SUBJECT: SEP TOPICS VI-2.D AND VI-3 EVALUATION REPORT
FOR MILLSTONE NUCLEAR POWER STATION, UNIT 1

SAFETY EVALUATION REPORT
ON
CONTAINMENT PRESSURE AND
HEAT REMOVAL CAPABILITY
SEP TOPIC VI-3
AND
MASS AND ENERGY RELEASE
FOR POSSIBLE PIPE BREAK
INSIDE CONTAINMENT,
SEP TOPIC VI-2.0
FOR THE
MILLSTONE 1 NUCLEAR POWER PLANT

DOCKET NO. 50-245

Figure 15. Drywell Pressure Response to a 0.01 ft² MSLB

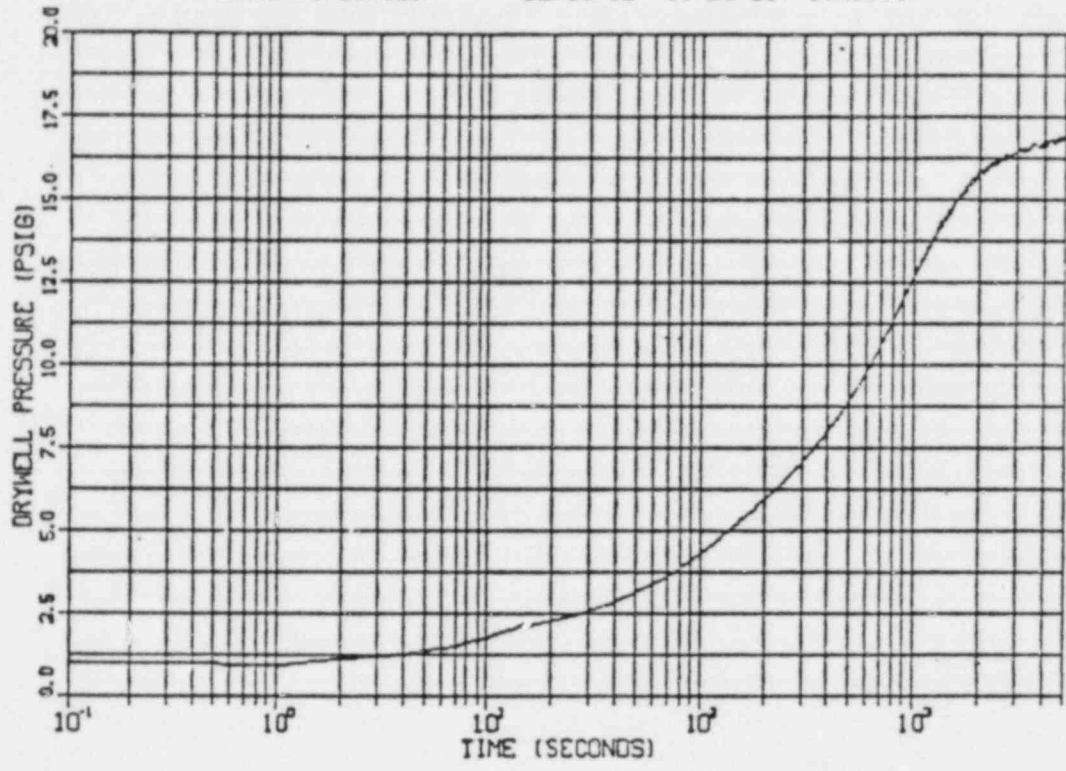
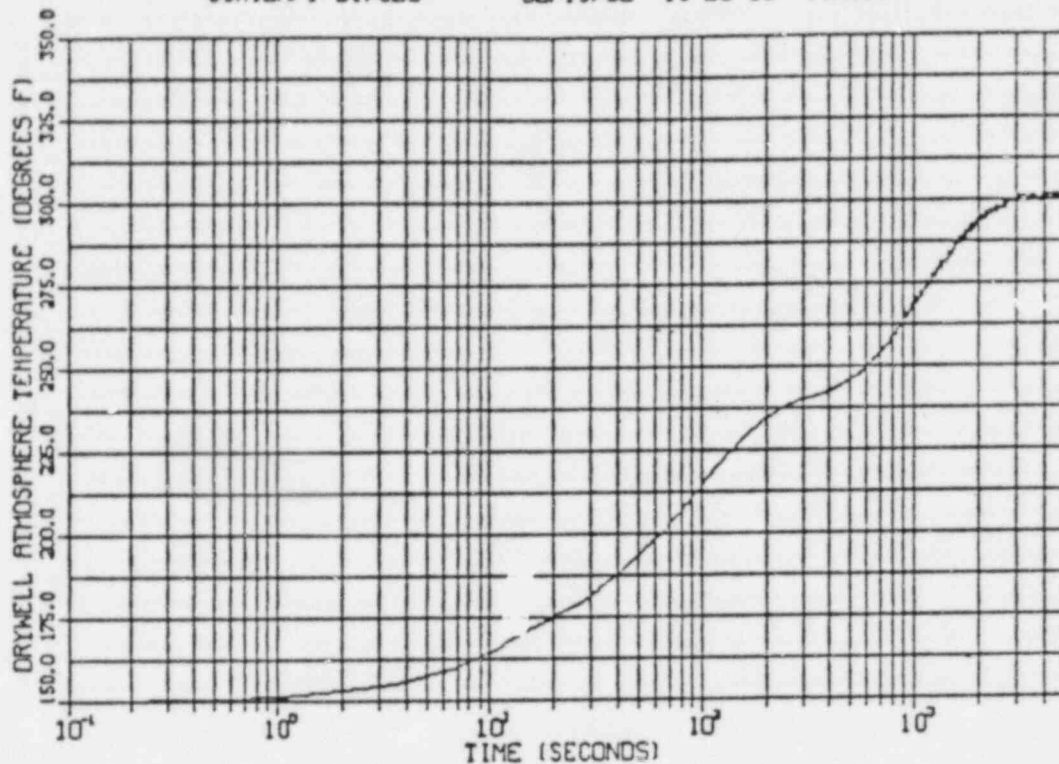
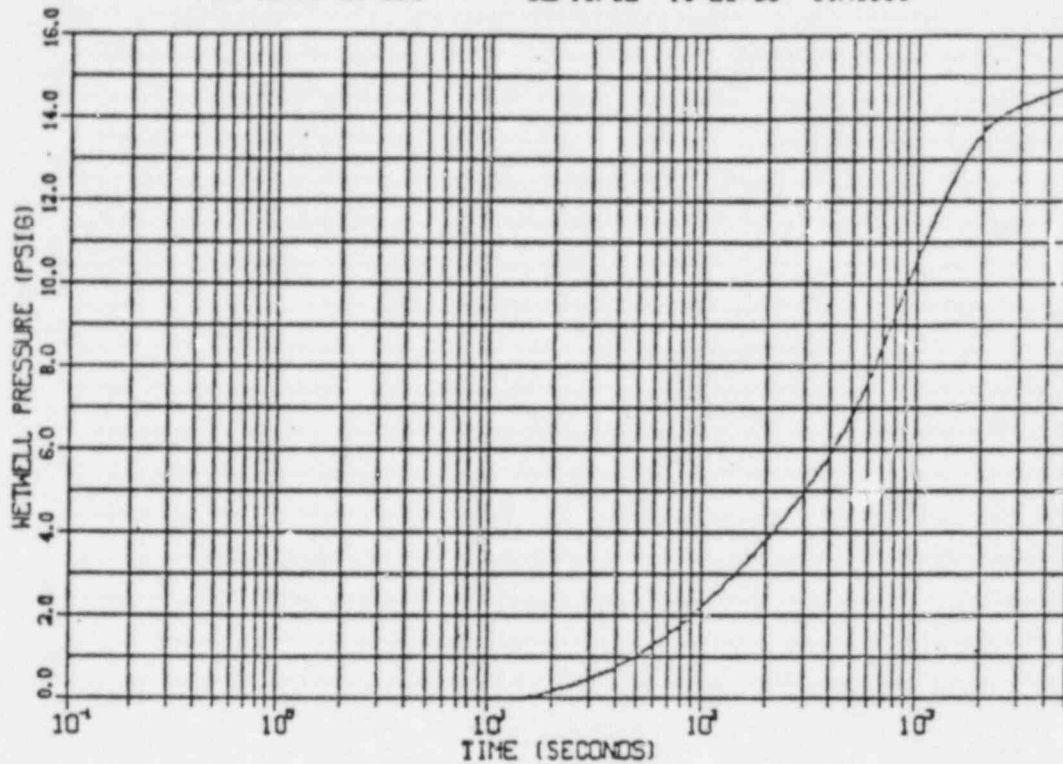
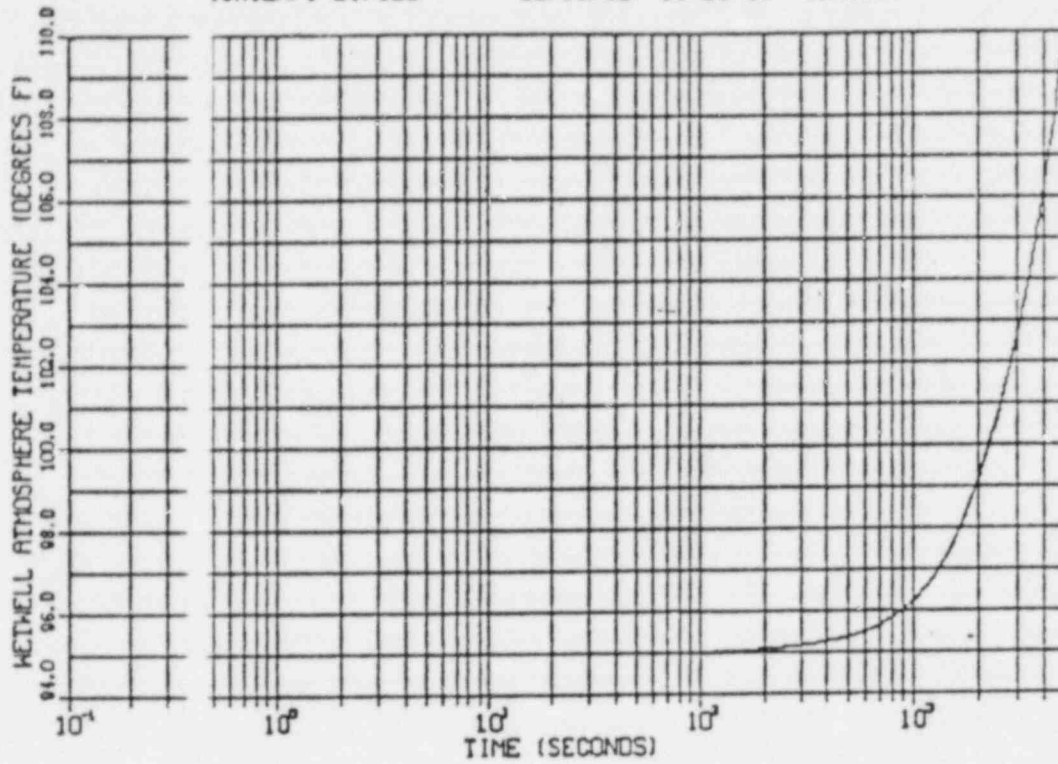
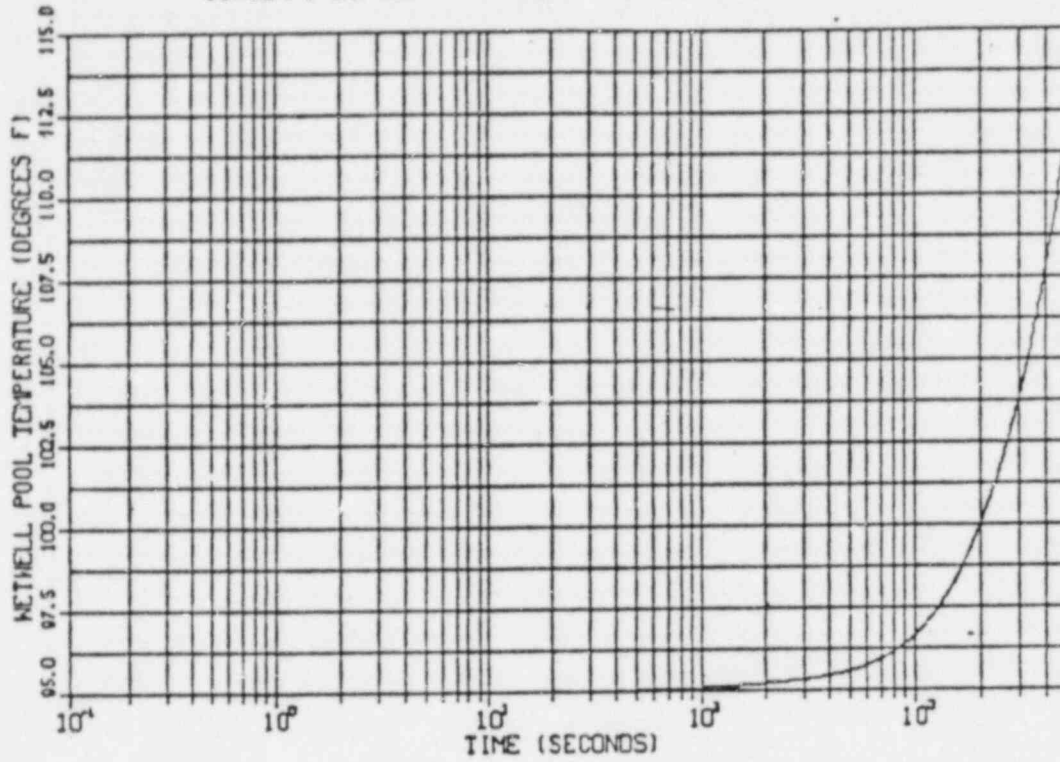
The calculated containment response to the 0.01 ft^2 MSLB shows a maximum drywell pressure of 16.7 psig and maximum temperature of 300°F . The wetwell maximum pressure and temperature are 14.7 psig and 111°F .
